4075 El Camino Way

Response Letter to Prescreening

Notice of Incomplete/Corrections Required
Application No. 23PLN-00202
09/13/2023

Project Description: Request for a Planned Community Zone Amendment to Allow New Additions to an existing Assisted 121 Units. The New additions include 14 Additional Assisted Living Units; 5 Studios and 9 One Bedrooms. The total Project elderly in need of day-to-day care for Memory Issues. Environmental Assessment: Pending. Zoning District: PC-5116 (F) Contact the Project Planner Emily Kallas at Emily.Kallas@CityofPaloAlto.org

DRAWING DESCRIPTION
Exterior Building Sections - Daylight Plane

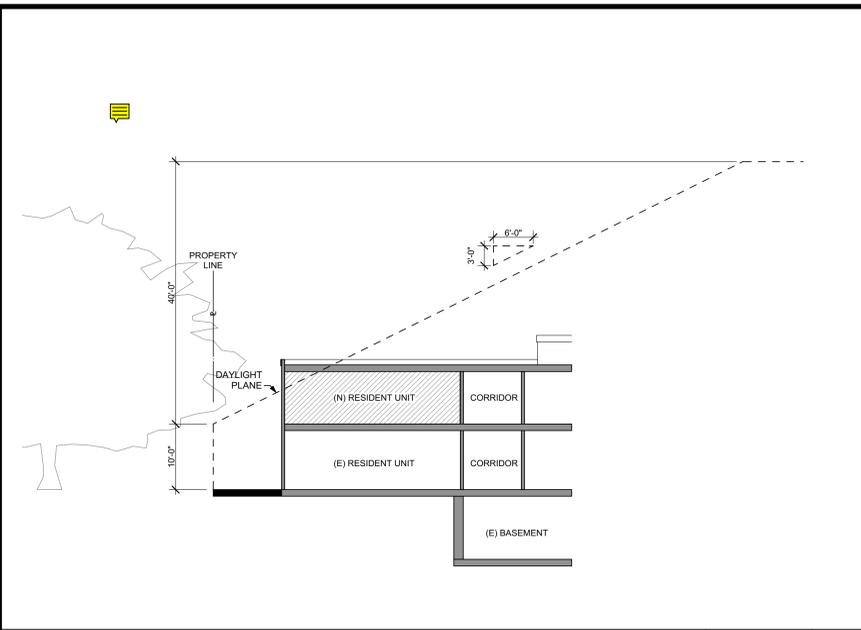
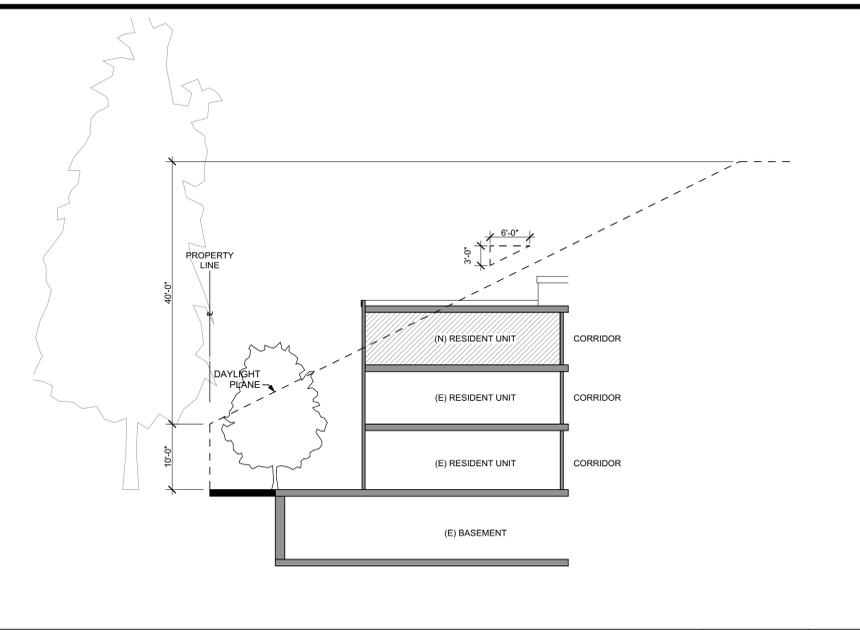
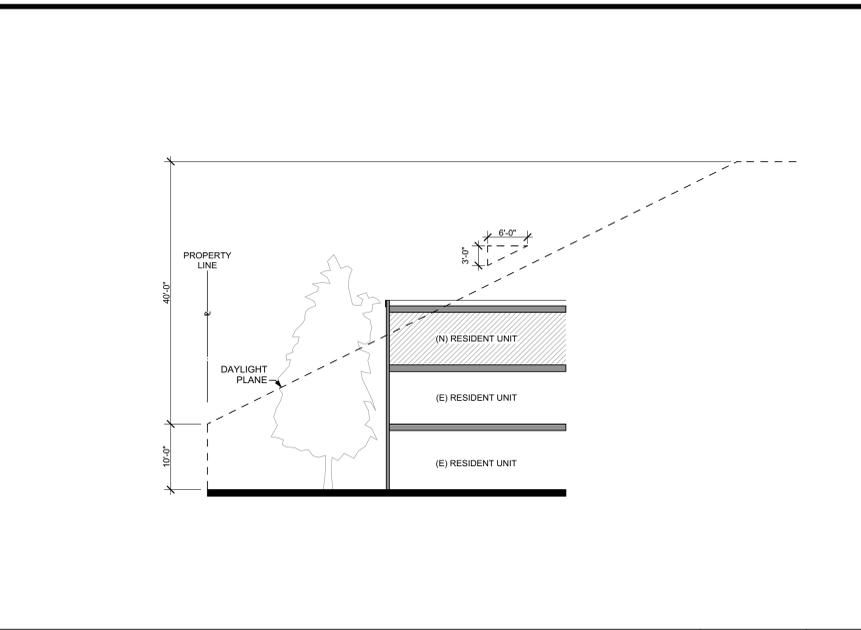
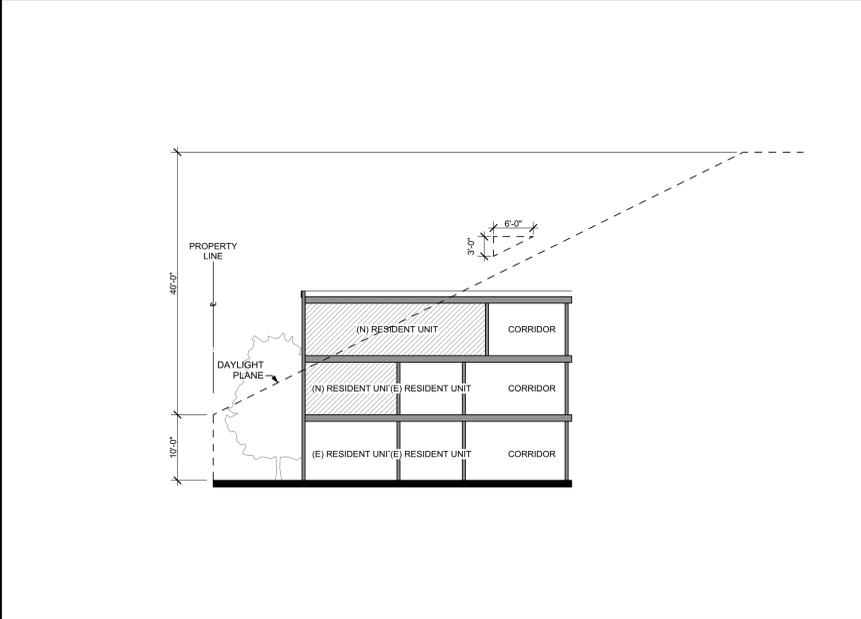
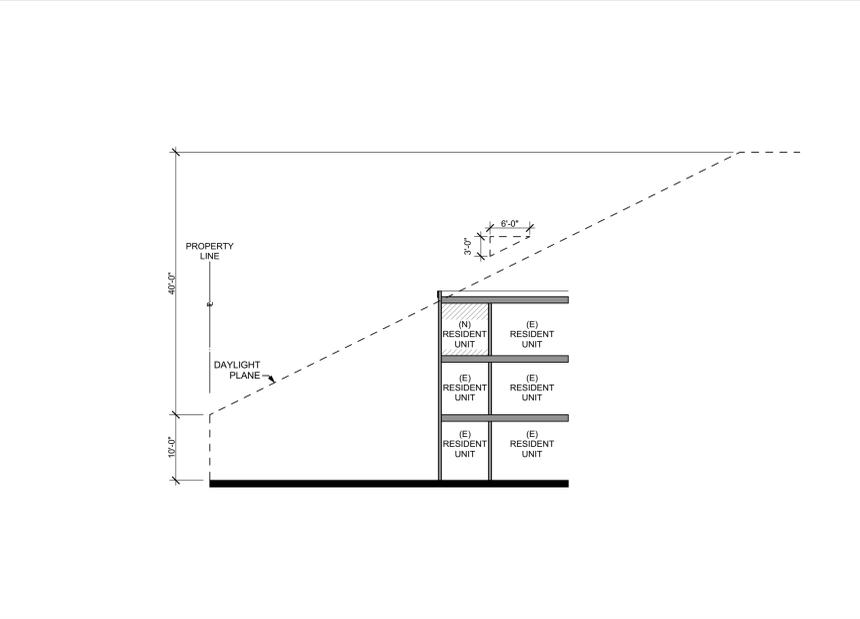
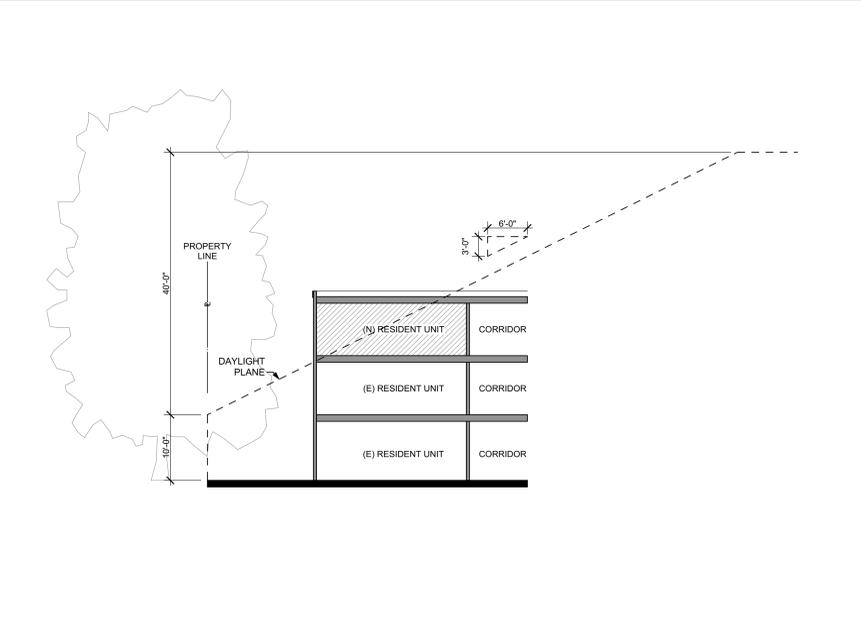
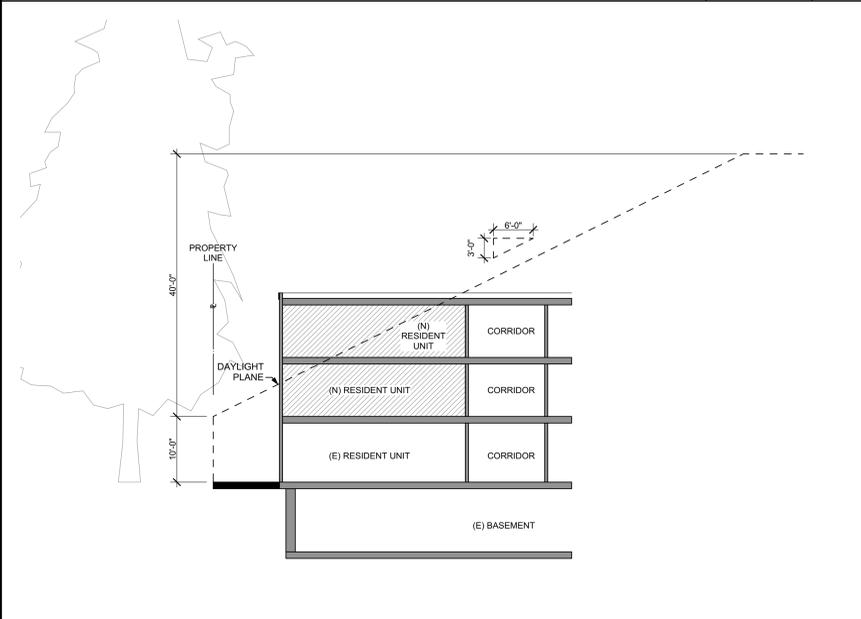
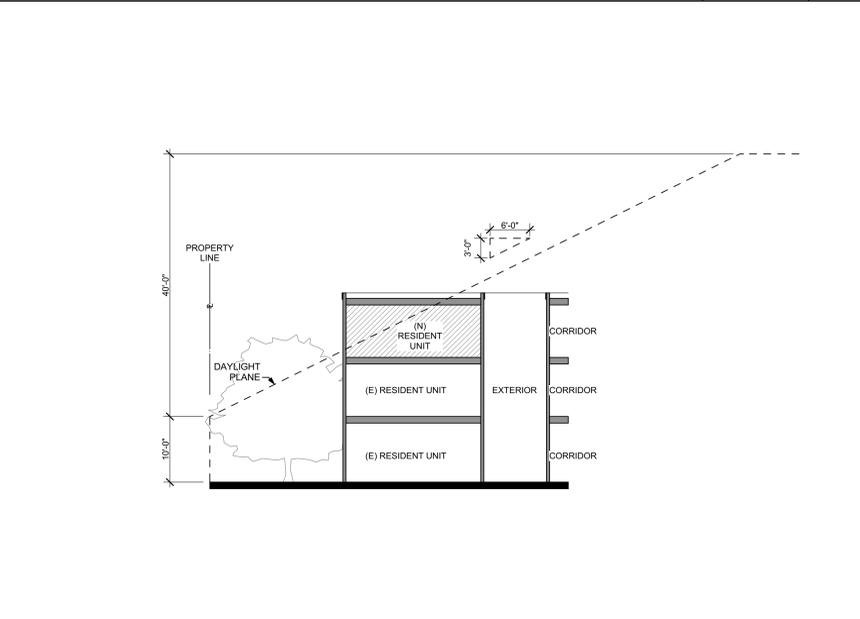
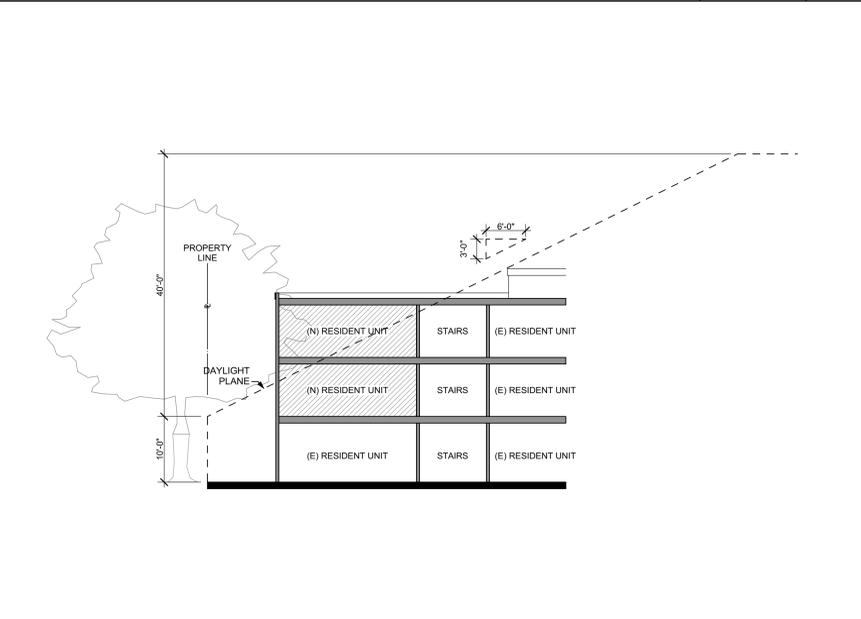
Page Reference	Annotation Type	Reviewer : Department	Review Comments	Applicant Response Comments
			<p>options. Does Medicare assist with any of the costs?</p> <ul style="list-style-type: none"> □ The shadow study that was briefly presented should be included in the formal plan sets, though it is ok if you are not ready with that today. □ Sometime after the 4th floor study has been prepared, and staff review of the 1st formal round is complete, I recommend you to host a Community Meeting to go over the project revisions with the neighbors. I have a couple different ways to moderate these types of meetings, and we can discuss those options further later. 	A5.9-A5.15: ADDED SHADOW STUDY TO THE SET
Title Sheet	Note	Emily Kallas : Planning	<p>Project Description Comments: Add a letterhead to the project description, clearly identifying it as written by the project applicant and/or property owner.</p>	A1.0: ADDED 2ND LETTER HEAD UNDER PROJECT DATA (1ST IS ON THE TOP RIGHT OF THE SHEET)
